COTTON CLOTHING LTD-

NEW Extension unit

Plot No. 27 (p) & 28 (p). Sataish Road, Gazipura, Tongi, Gazipur 1712.
(23.919936, 90.388819)
13th January, 2019

Observations

Roof Layout plan

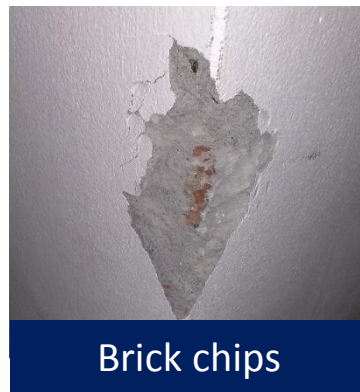
**Column to be stressed above normal
design limits**

Cursory calculations indicate that columns under water tank would appear to be stressed in excess of normal design limits, assuming minimum concrete strength (stone chips aggregate). Building Engineer to review design, loads and columns stresses.

Two types of aggregate (Brick and stone chips) had been used in column construction. Most of the test report was available for brick chips concrete. Building engineering is required to confirm the aggregate type and concrete strength of ground floor columns.

Beam Layout

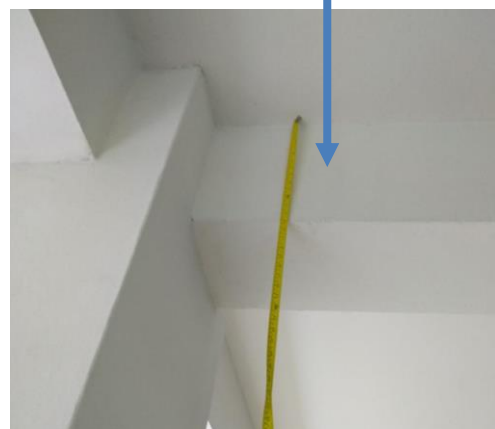
Periphery beam at west stair was missing but which is shown in beam layout. Also depth of longitudinal beams were found 500 mm instead of 450 mm.

Missing beam

Beam size

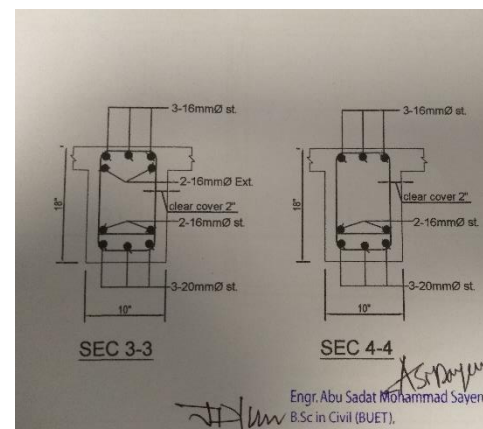
15 inch d/s measured

Column Schedule

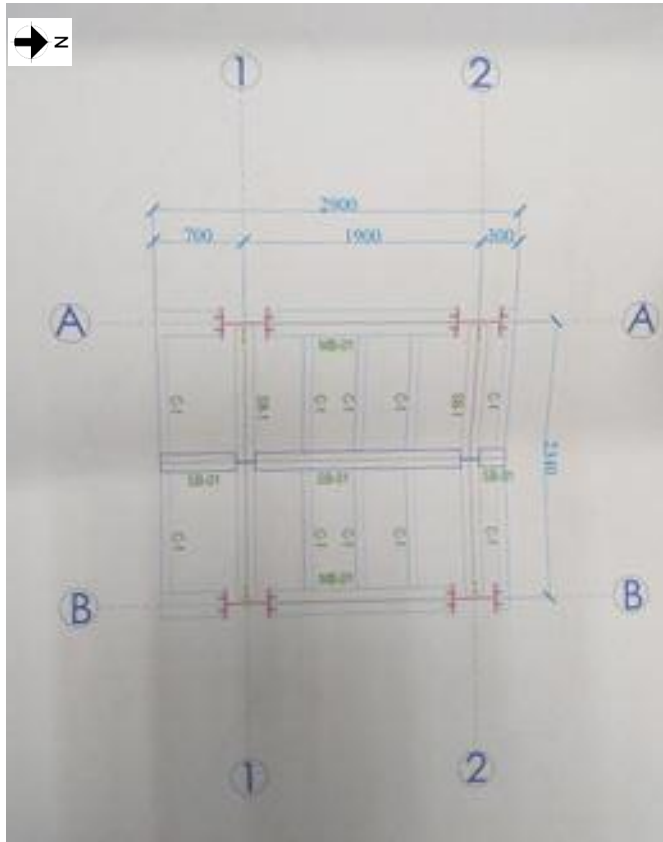
Rebar dia. of few columns were measured 16 mm at roof level whereas column schedule shows 20 mm at all level.

Rebar Diameter
